For: Modular Sensor Platform

This is a Preliminary Amendment being filed at the same time as the original Application for a Patent for a Modular Sensor Platform filed on **01/30/02** with first named Inventor, Young

FIGURE 2

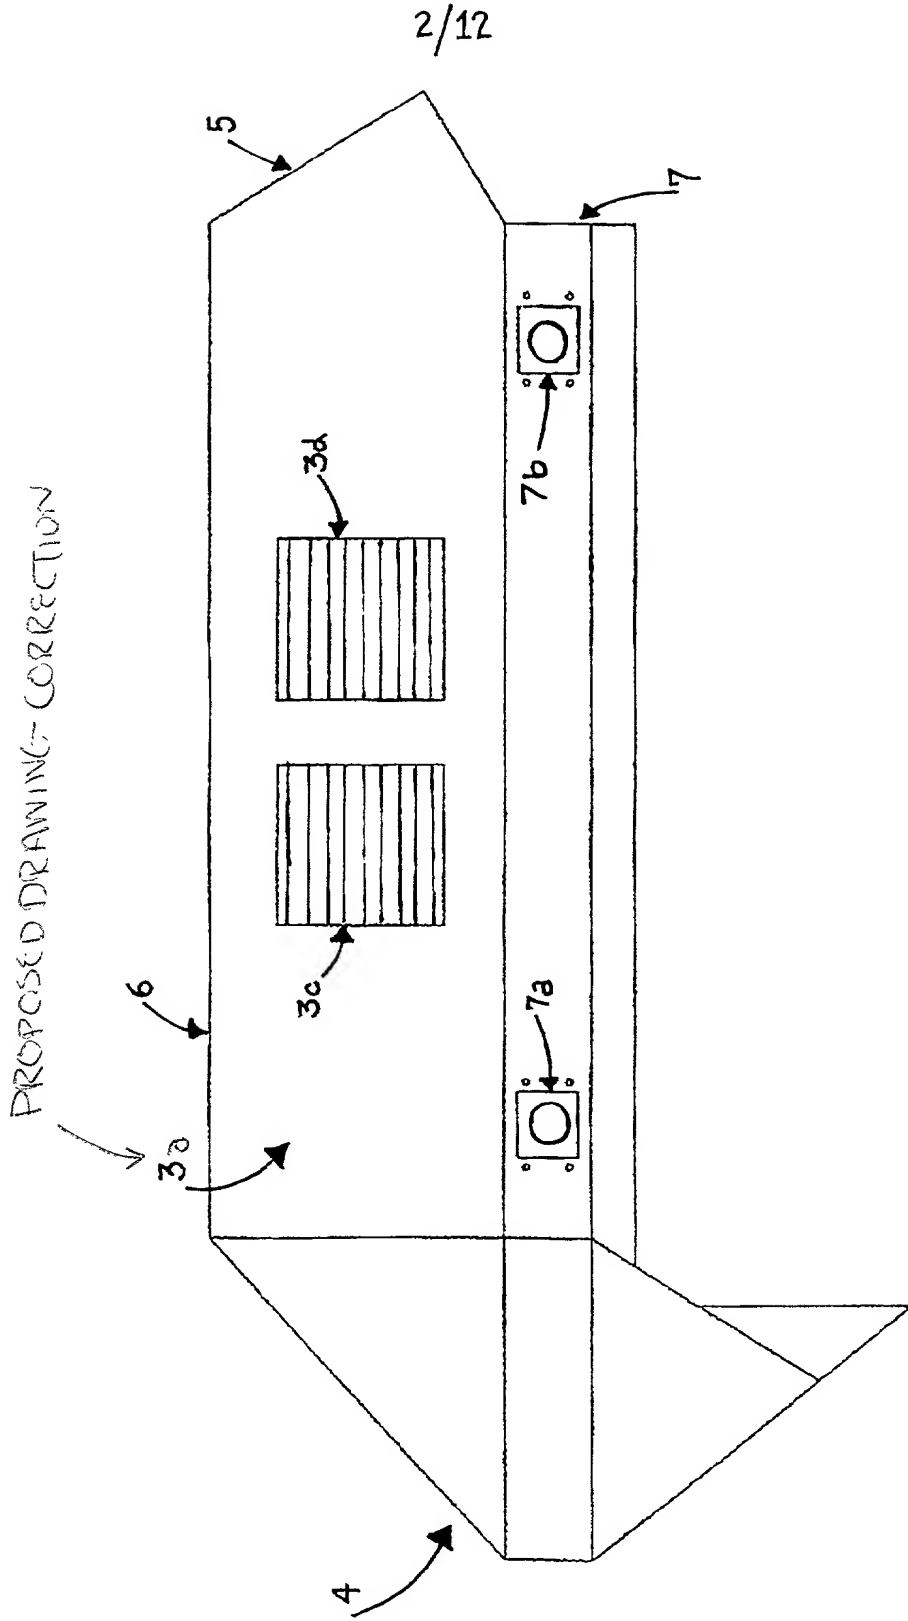
Applicant proposes to make Drawing Corrections to Figures 2, 3(d), 5(c) and 6 to insert omitted reference numbers.

PROPOSED DRAWING CHANGE

FIGURE 3(d)

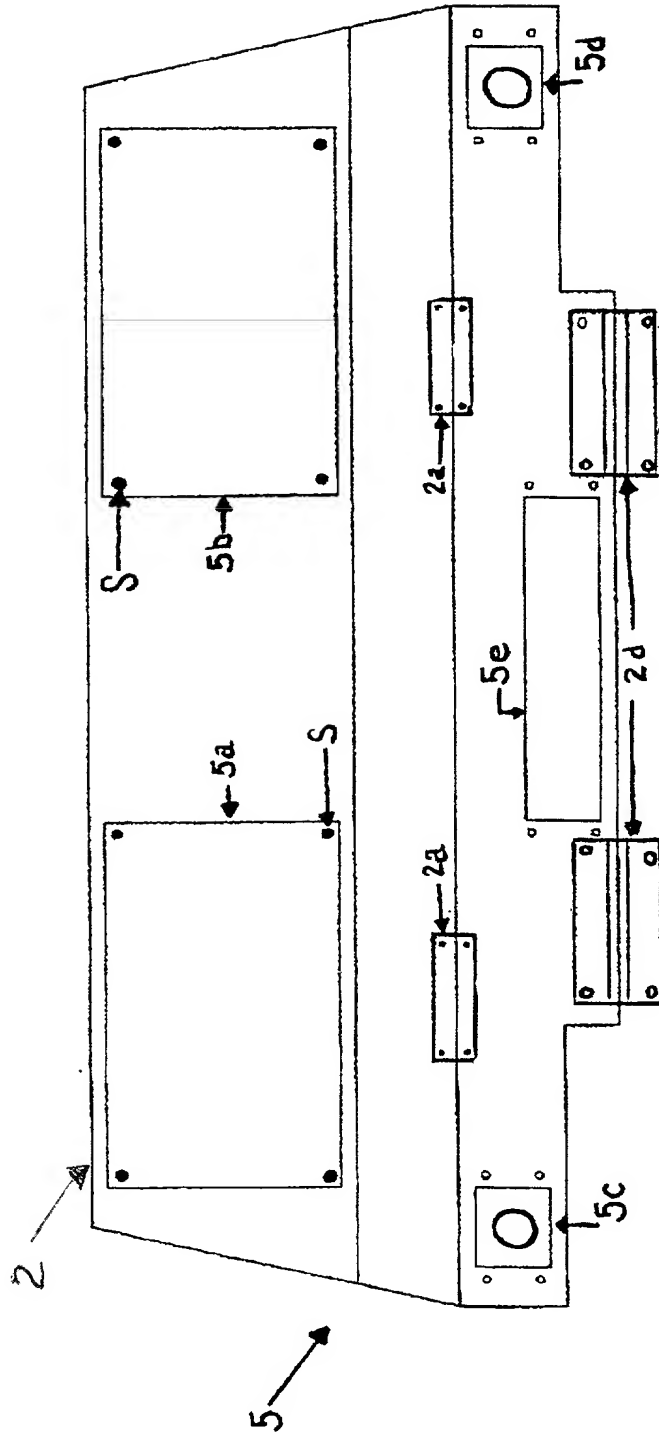
PROPOSED DRAWING CHANGE

FIGURE 5(C)

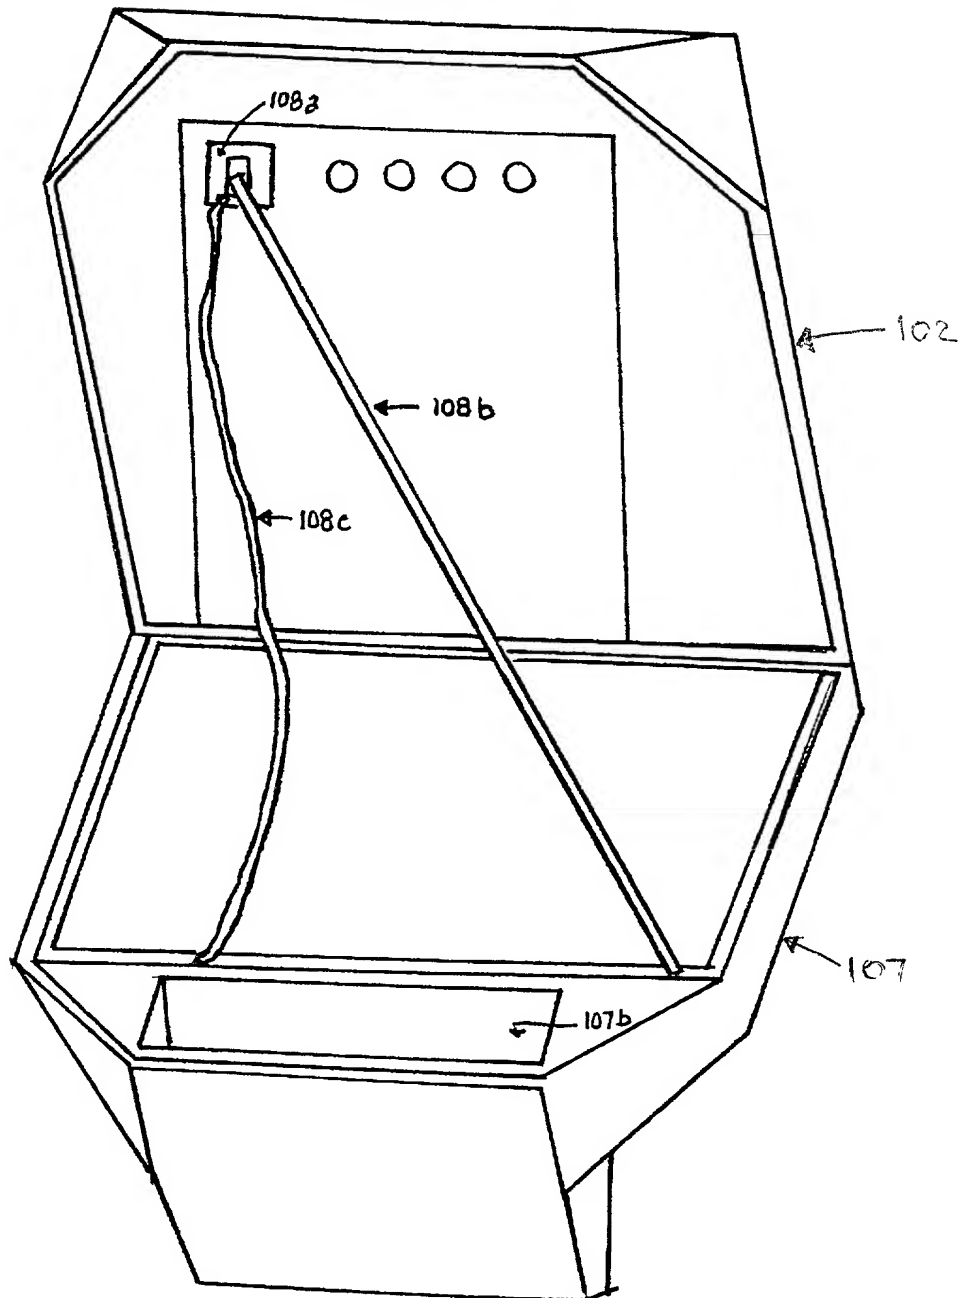
PROPOSED DRAWING CHANGE
